UMTRA PROJECT OFFICE
PROJECT INTERFACE DOCUMENT

Site Durango, Colorado	Date 12/31/96	PID No. 03-S-41	Site No. 03	Vic Pro No.
Originator and Location Tom Jernings, APO	Phone (505) 766-1667	Organization MK-Ferguson	Answer By:	References: Subcontract: Subcontract No: DUR-86-02
Subject Extension of Subcontract Completion Date

U. S. DEPARTMENT OF ENERGY
ALBUQUERQUE DISTRICT OFFICE
NUNATAK SITE
MOJO CANYON DISPOSAL SITE
EMBANKMENT EROSION PROTECTION

Site Durango	Date 8/09/90	PID No. 03-S-30	Site No. 03	Vic Pro No.
Originator and Location M. L. Wesely, SF	Phone 415/442-7511	Organization MKES	Answer By:	References: Subcontract: Subcontract No:
Subject Redesign of the Ditch No. 1 Outlet and Two Drainage Outlets Along Ditch No. 2

FIGURE 7: REVISIONS OF EDGE DETAILS ON WESTERN SLOPE AND SOUTHWESTERN DRAINAGE ALONG DITCH NO. 2

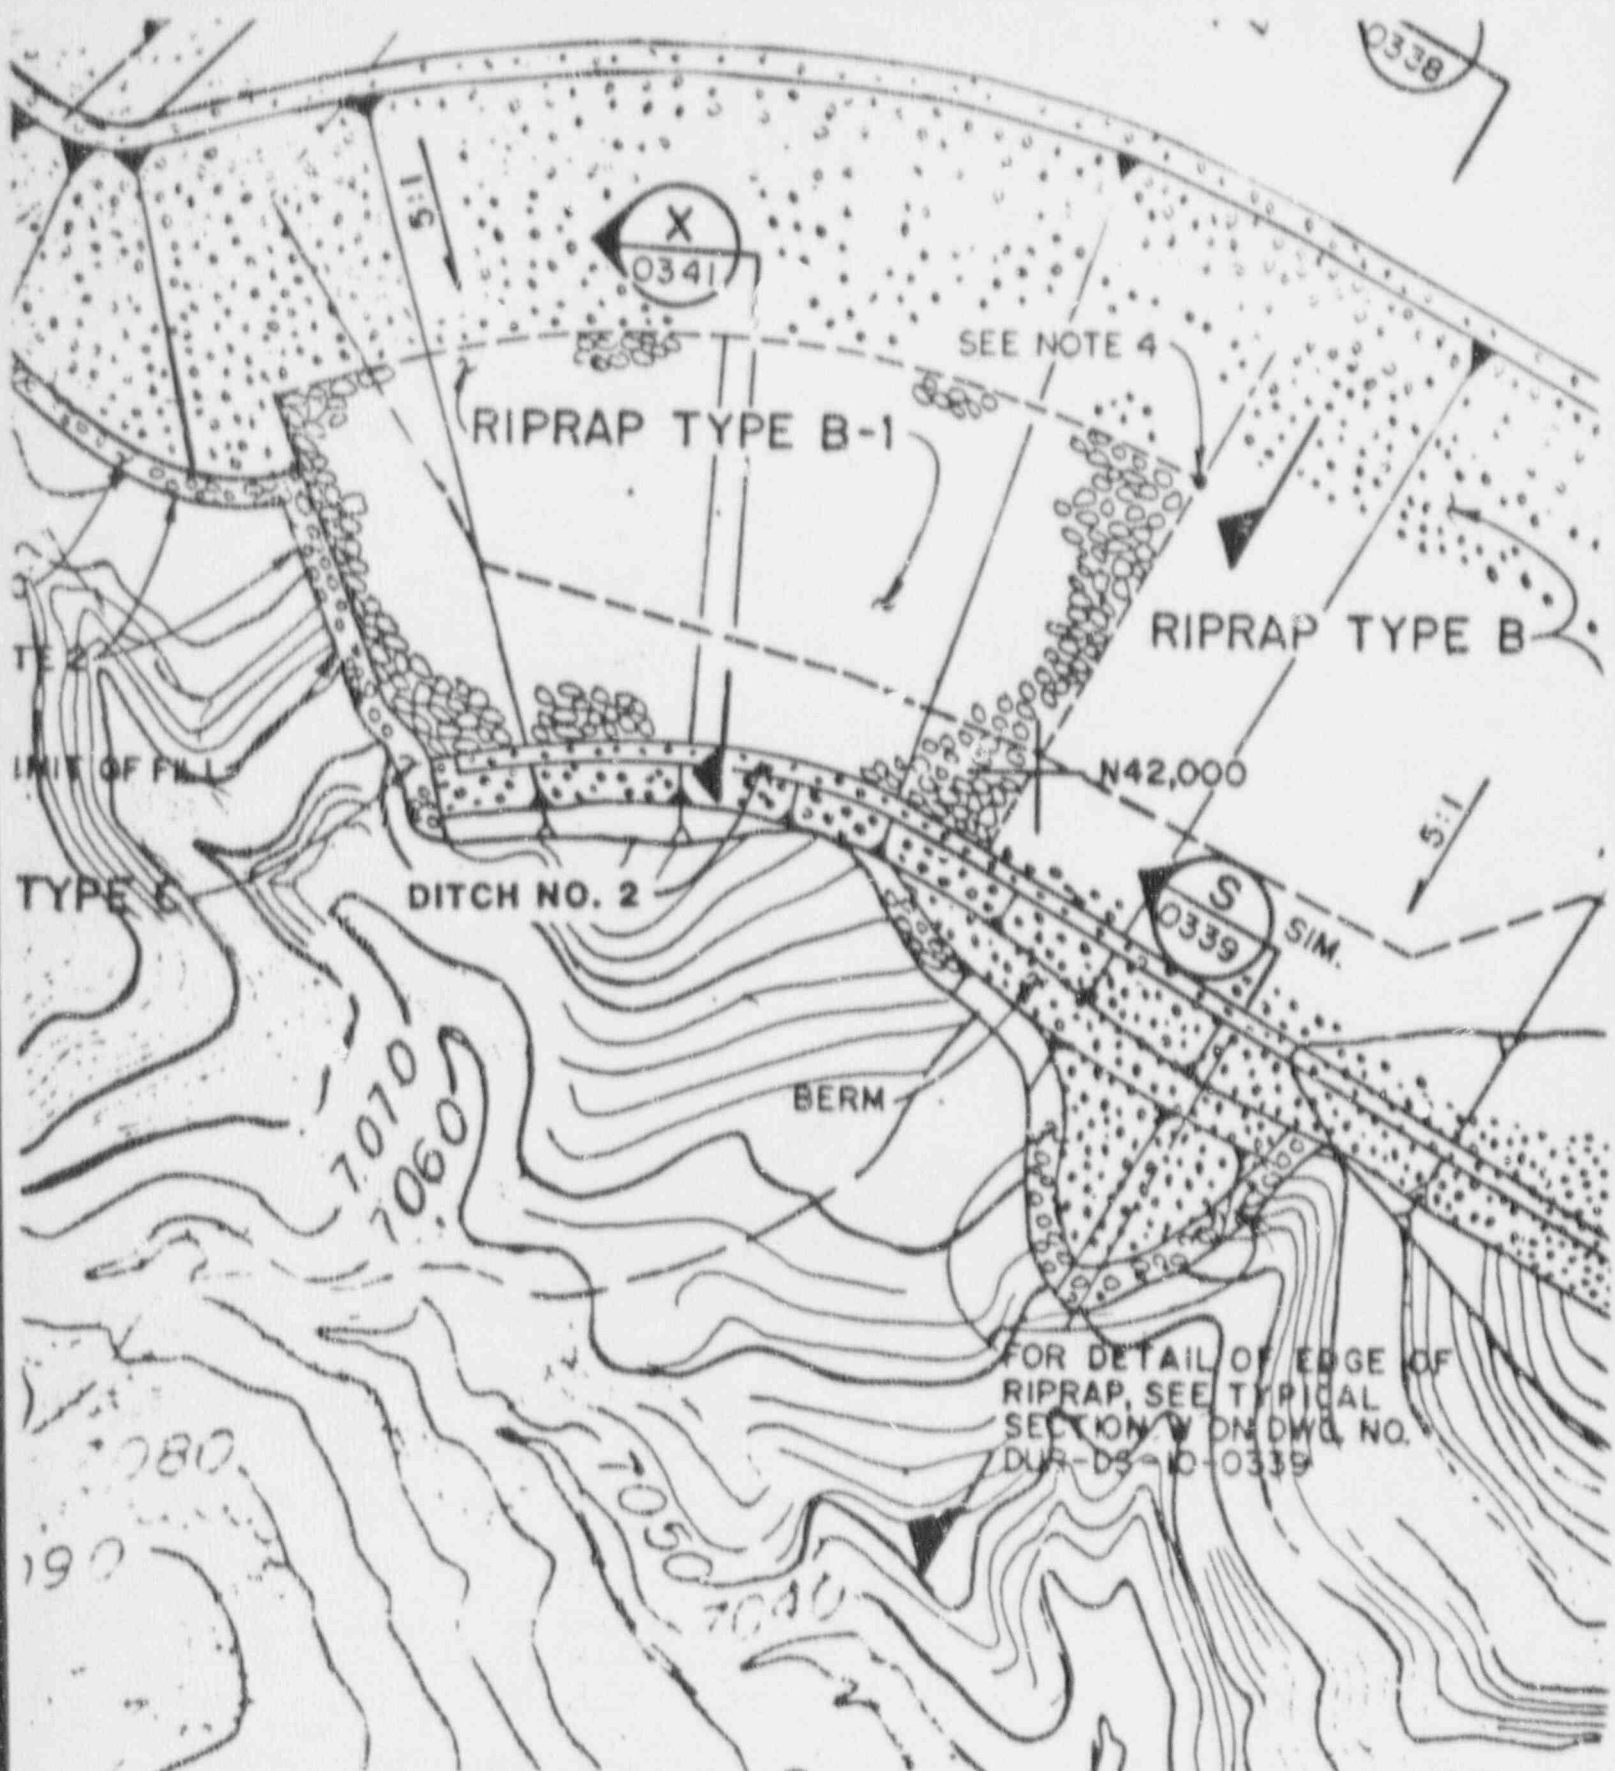
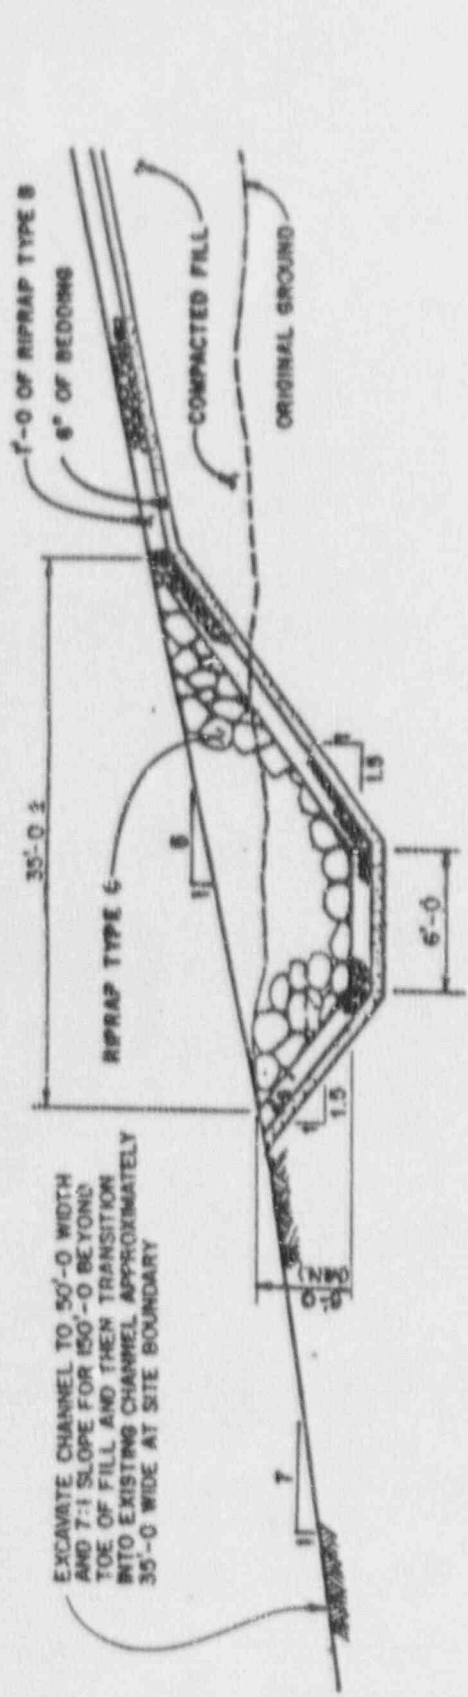
PROBLEM 2: A similar situation of bedrock not encountered for a considerable distance occurs along the southern Ditch No. 2. Two small regions on the outside edge of the ditch were covered with riprap and edged with a key trench and spillway. During installation of temporary retention basins DS-3 and DS-4 rock was not encountered. Test pits in these regions indicate depths up to 23 feet. The site boundary, adjacent to the southeastern drainage, limits extension of the design if the trench must be excavated to key into competent bedrock.

The southeastern and southwestern riprapped key trenches were also reevaluated. The drainage areas for both are quite small as shown in the attached supporting calculation. The proposed revisions are shown in Figure 7 and Figure 8 and include:

- o Removal of the words "key into bedrock",
- o Section W to be included in both areas and the top width set at approximately 24 feet,

PROBLEM 3: On the western edge of the disposal cell, the key trench is duplicated on an inner edge rather than only edging the outside rim. This extra detail is not necessary for maintaining a raw edge since it is in the middle of a 5:1 riprapped slope.

EXCAVATE CHANNEL TO 50'-0" WIDTH AND 7:1 SLOPE FOR 150'-0" BEYOND TOE OF FILL AND THEN TRANSITION INTO EXISTING CHANNEL APPROXIMATELY 35'-0" WIDE AT SITE BOUNDARY

SOLUTION 2: Revise Drawing DUR-DS-10-0337 per Figure 7 and revise Sections W on Drawing DUR-DS-10-0338 and Section S on Drawing DUR-DS-10-0339 per Figure 8. Revise Note 5 on Drawing DUR-DS-10-0335 to read "5. Existing channel shall be widened as noted in Section S on Drawing DUR-DS-10-0339."

SOLUTION 3: Remove the inner key trench in the middle of the 5:1 slope on Drawing DUR-DS-10-0337 per Figure 7.
